# The Real Emissions of Peterhead-CCS

## Key Findings

This report estimates the real emissions of the proposed Peterhead gas power plant with carbon capture by SSE & Equinor. The main goal is to assess whether the emissions reported in the Environmental Impact Assessment report provide an accurate estimate of the future emissions of this project.

**FIG 1: SCHEMATIC REPRESENTATION OF THE UK'S FUTURE NATURAL GAS SUPPLY OUTLOOK**

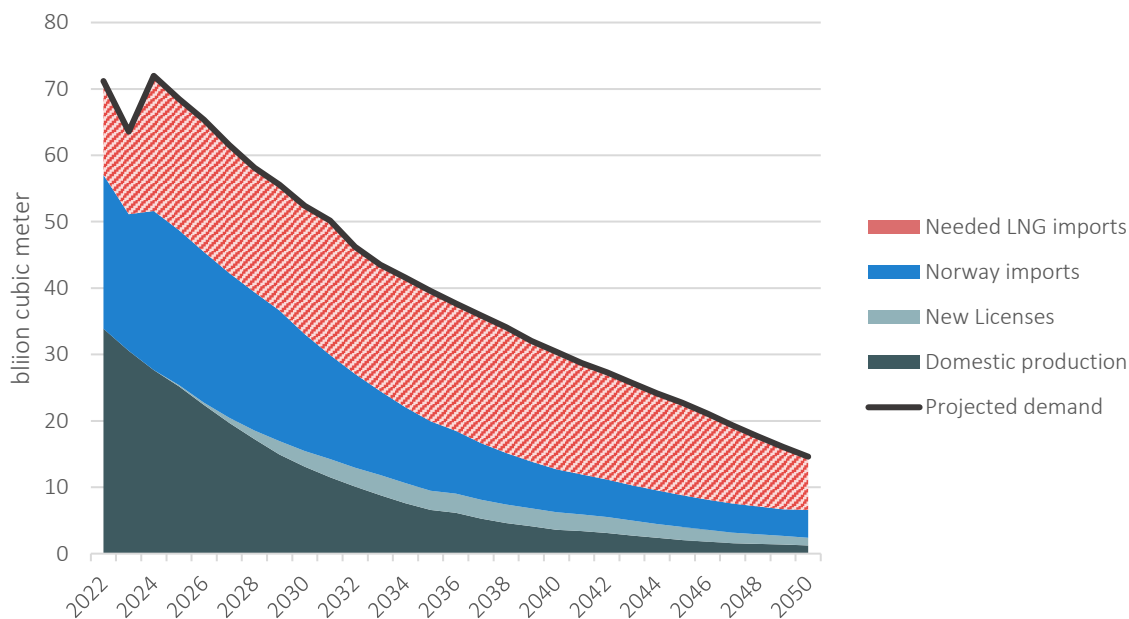
In the next decade, this trend is set to worsen. Production from the North Sea, even including the unlikely development of future reserves, is expected to drop much faster than demand, widening the already growing gap between supply and demand. Our analysis suggests that in the 2030s the UK could rely for more than half of its supply on imported LNG, especially from the USA and Qatar. As a result, the emission intensity of the average gas supply mix could increase by 50% compared to today, see Figure 1 and Table 1.

**FIG 2: ANNUAL EMISSIONS PETERHEAD-CCS, REPORTED VS CARBON TRACKER ESTIMATES**

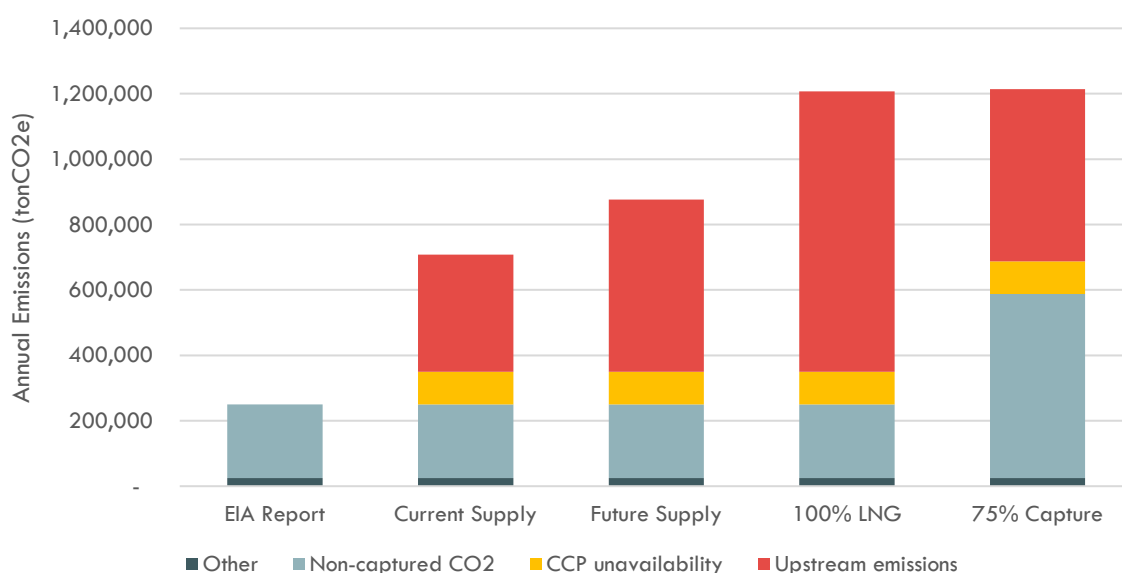
However, our scenarios show that the omission of upstream emissions, CCP unavailability and partial capture would dramatically increase the project's climate impact, see Figure 2.

Accounting for periods when the plant would run in unabated configuration due to unavailability of the carbon capture plant would increase annual emissions by 40% compared to the baseline case. We accounted for a conservative estimate of a 95% availability factor for CCP, which translates into roughly 18 days of unplanned outages per year.

Upstream emissions increase the climate impact further. Even using today's supply mix, upstream emissions would increase total emissions by 140%. However, as mentioned above the future gas supply mix is expected to change significantly due to the expected drop in domestic production and consequent increase in LNG imports. In that case, annual emissions could reach 709,000 tonCO<sub>2</sub>e, 3.5 times higher than the emissions reported in the EIA report. Emissions would grow even further in case the plant would run on 100% imported LNG, reaching 1,207,000 tonCO<sub>2</sub>e, almost five times higher than reported.

Finally, the scenario with the 75% capture rate would reach 1,214,000tonCO<sub>2e</sub> per year, almost five times higher than the values reported in the EIA documentation. Note that under this scenario, the project would still be eligible for UK Government subsidy regardless of the high climate impact<sup>17</sup>.

**FIG 3: LIFETIME EMISSIONS PETERHEAD-CCS REPORTED VS CARBON TRACKER ESTIMATES**

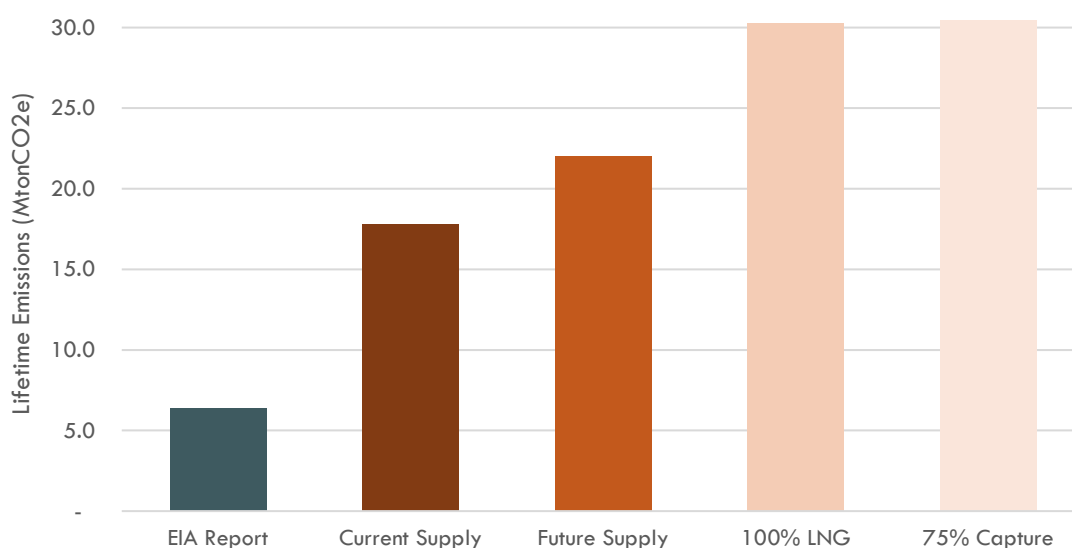
In aggregate, **we found that the scenarios presented in the EIA Report severely underestimate lifetime emissions.** We estimate that the real emissions of the Peterhead-CCS during its planned 25 years of operation could be between 2.8 to 4.8 higher than reported in SSE's EIA Report. We estimate that lifetime emissions could range from 18 to 31 million tonnes of CO<sub>2</sub> equivalent (MtonCO<sub>2e</sub>) compared to only 6.3 MtonCO<sub>2e</sub> reported by the developer.
